PROJECT PROPOSAL

The revitalization of the site at 1015 Second Avenue incorporates the rehabilitation of the former Federal Reserve Bank building and addition with 7 floors of office, in addition to the conversion of the roof of the existing building and the roof of the addition to include occupied spaces.

SECTION 02. EDG GUIDANCE AND RESPONSE

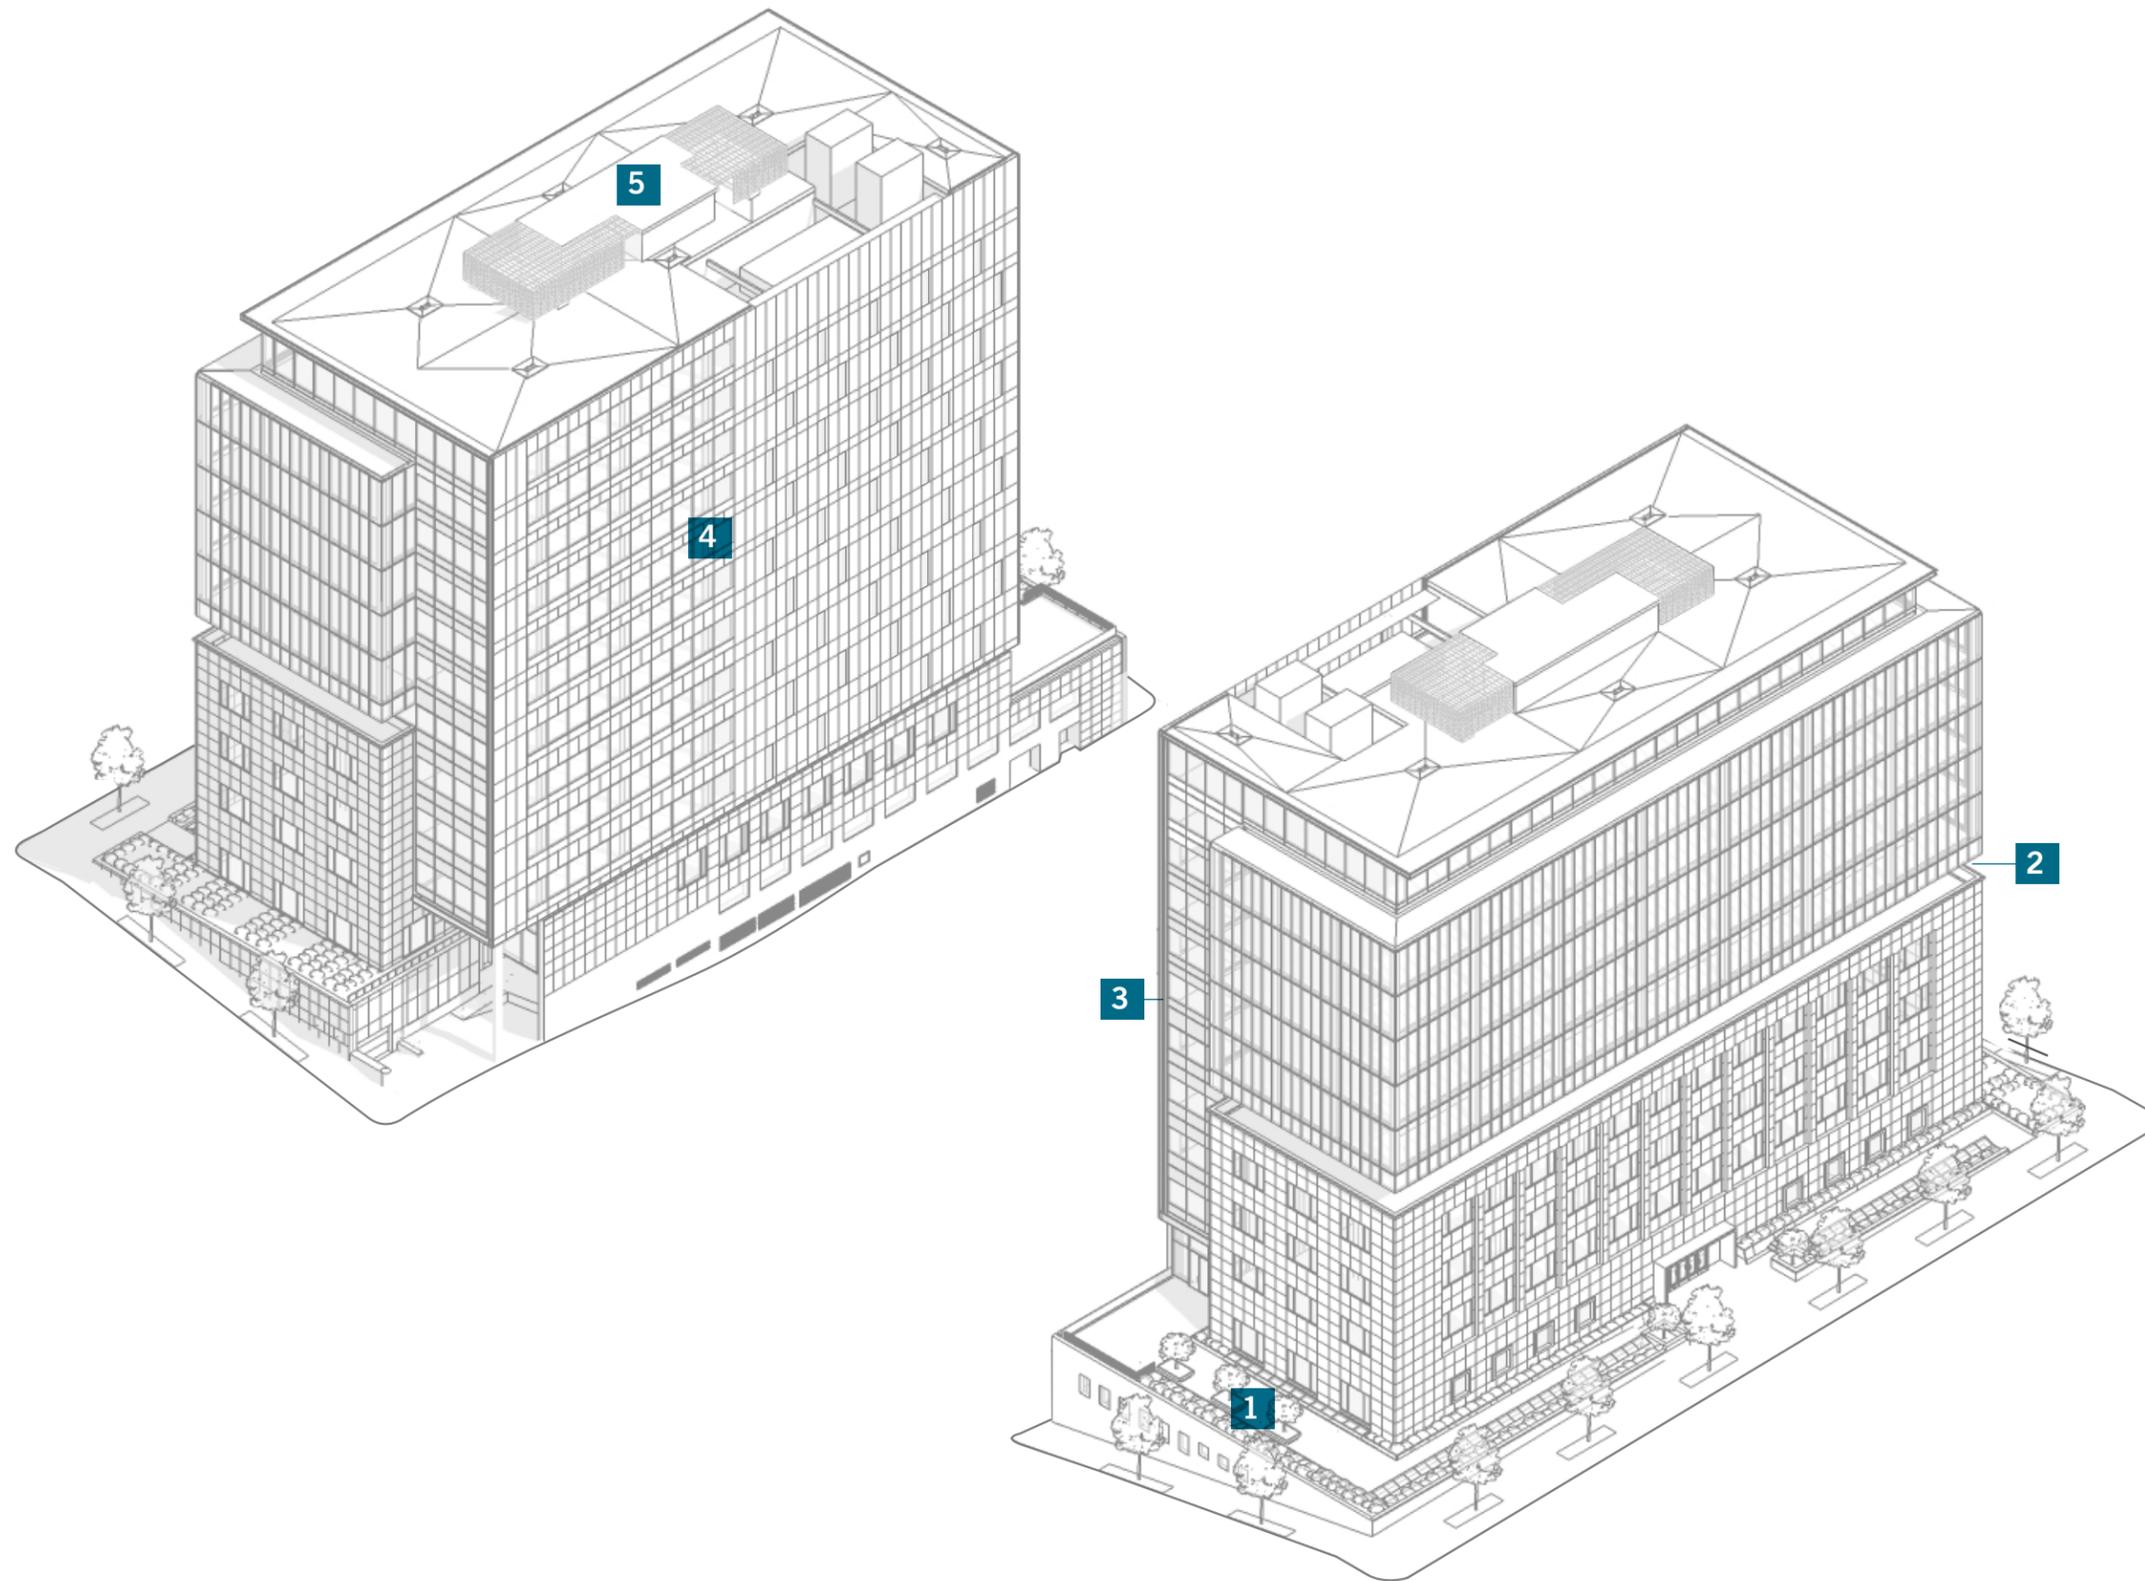
- 1** The Board noted that they would like to see a greater opportunity for a public benefit in the plaza above Madison Street. Give it public access and bring it as close as possible to the sidewalk on Madison, even though it sits above the sidewalk level.

1 Enhanced Plaza

The plaza has been made accessible and enhanced with plantings, skylights, pavers and lighting. The right of way has also been improved with street trees and lighting.

ROOFTOP STRUCTURES AND EQUIPMENT /

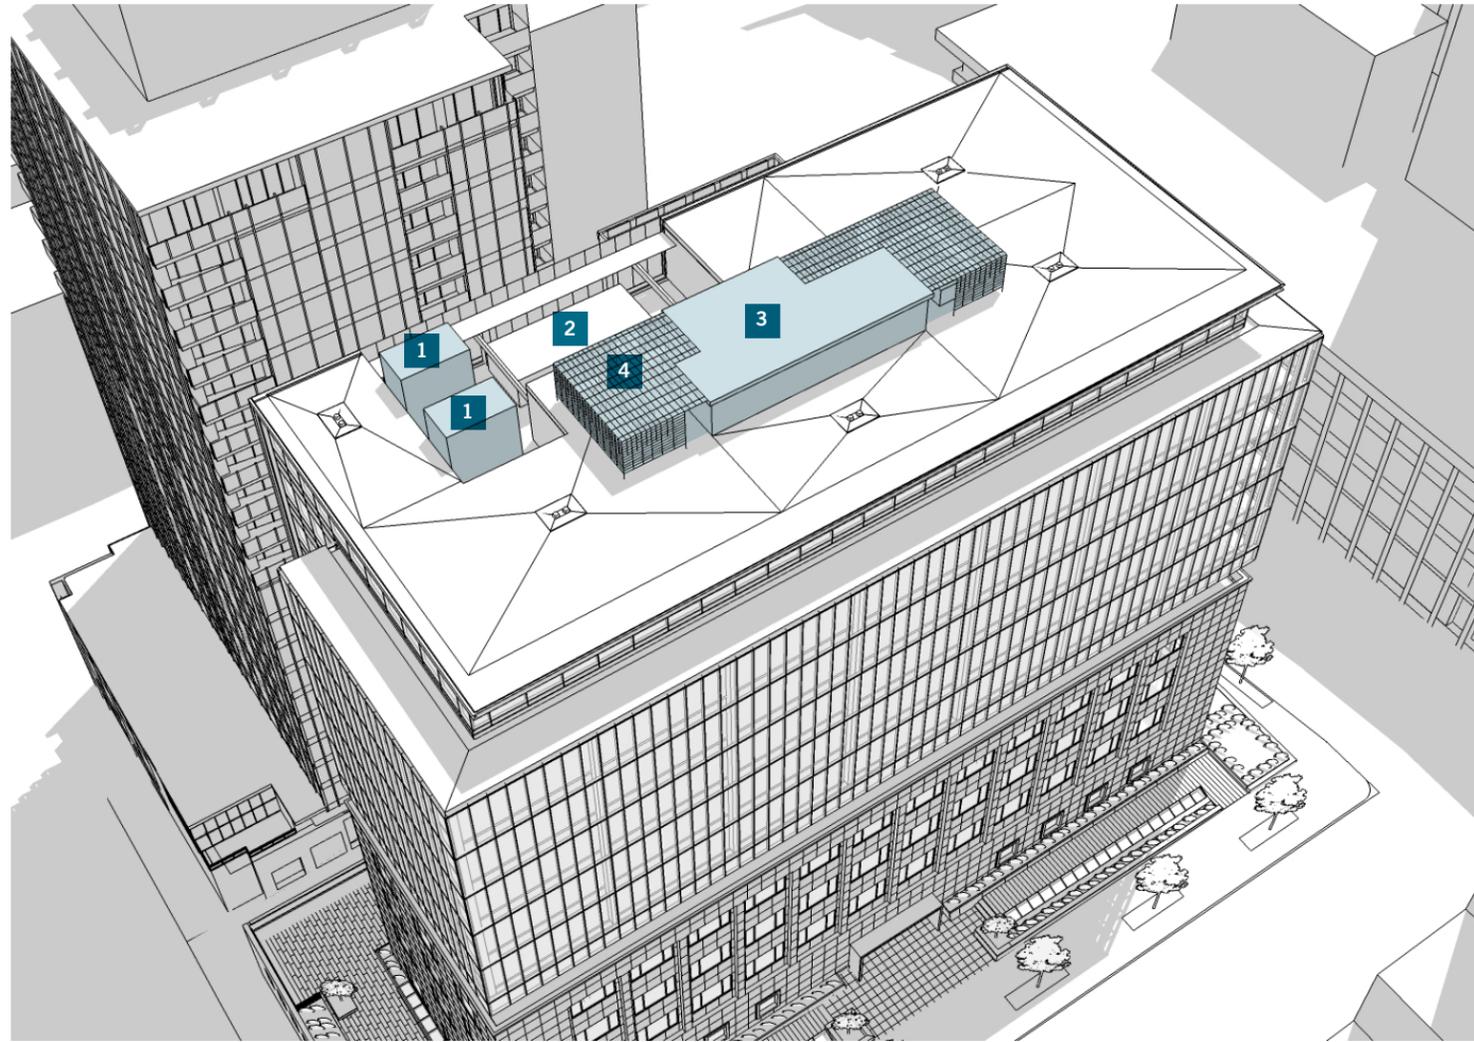
- 5** Recess the mechanical systems as had been shown in renderings at the meeting, and be prepared to demonstrate at Recommendation time, even greater particularization of mechanical elements.

5 Rooftop Mechanical

Mechanical systems are recessed to the greatest extent possible. Elevator overruns and control rooms are positioned to minimize visibility from the street and pressurization fans are collected with a screened enclosure.

The largest components of the mechanical system are located in a recessed, exterior mechanical well on level 13. Life safety equipment related to the exit stairs and elevators is located on the high roof and organized within a screened enclosure. Rendered perspectives and sketch vignettes illustrate that the equipment and penthouse is not visible from street level in the immediate vicinity of the building, but becomes partially visible from further south on Second Avenue and from up the hill on Madison Street.

VIEW CORRIDOR /

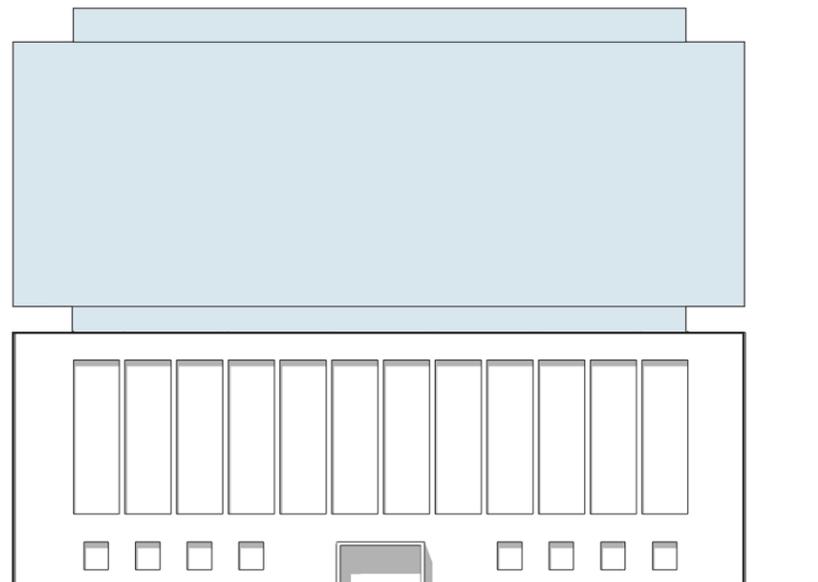
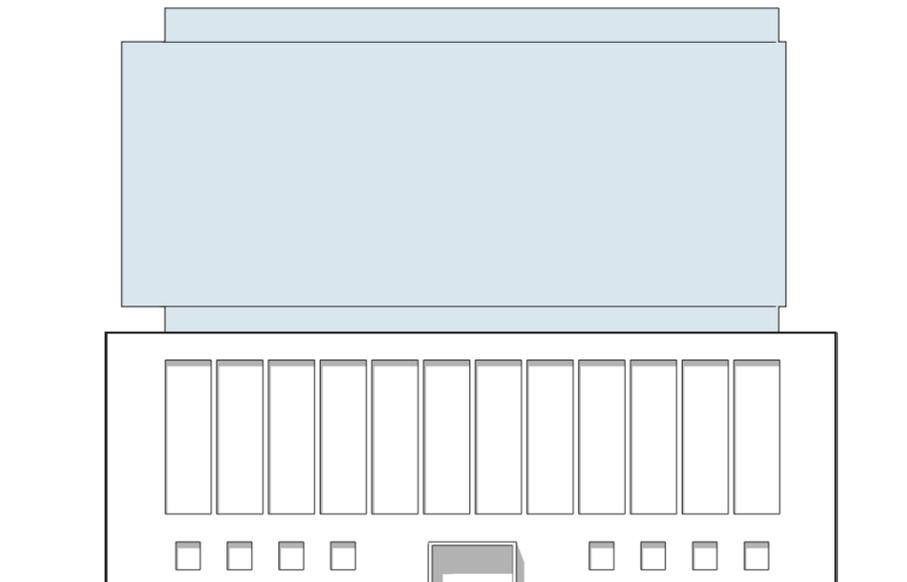
The Board agreed with the Architectural Review Committee that a waiver should be granted from the view corridor requirements (SMC 23.49.024) on both Spring and Madison Streets. As proposed, the addition would share the same setbacks as the historic building (which is not situated symmetrically on its lot) and the addition would produce a more unified and well-proportioned composition in keeping with Design Guideline B-4.

"The Board agreed with the Architectural Review Committee that a waiver should be granted from the view corridor requirements (SMC 23.49.024) on both Spring and Madison Streets. As proposed, the addition would share the same setbacks as the historic building (which is not situated symmetrically on its lot) and the addition would produce a more unified and well-proportioned composition in keeping with Design Guideline B-4"

Director's decision requested to allow the massing of the addition and existing Landmarked structure to be set back 26'-1" at Madison Street and 16'-2" at Spring Street above a height of +36' from the Second Avenue sidewalk.

In order to reinforce and strengthen the existing proportions of the FRB, the addition shares the same setbacks as the historic building and is consequently nonconforming with SMC23.49.024. The ARC was supportive of the proposed approach because compliance with view corridor requirements produces a "hat box" addition with a weaker relationship to the historic base. The massing of the proposed addition produces a more unified and well-proportioned whole in response to Design Guideline B-4.

The ARC deliberated on the issue of the asymmetry of a strictly compliant addition versus a symmetrically setback addition and the consensus was that in either case a "hatbox" addition would be undesirable, and that a unity of old and new would provide better compatibility and be achieved with the mass of an addition aligned to the historic.
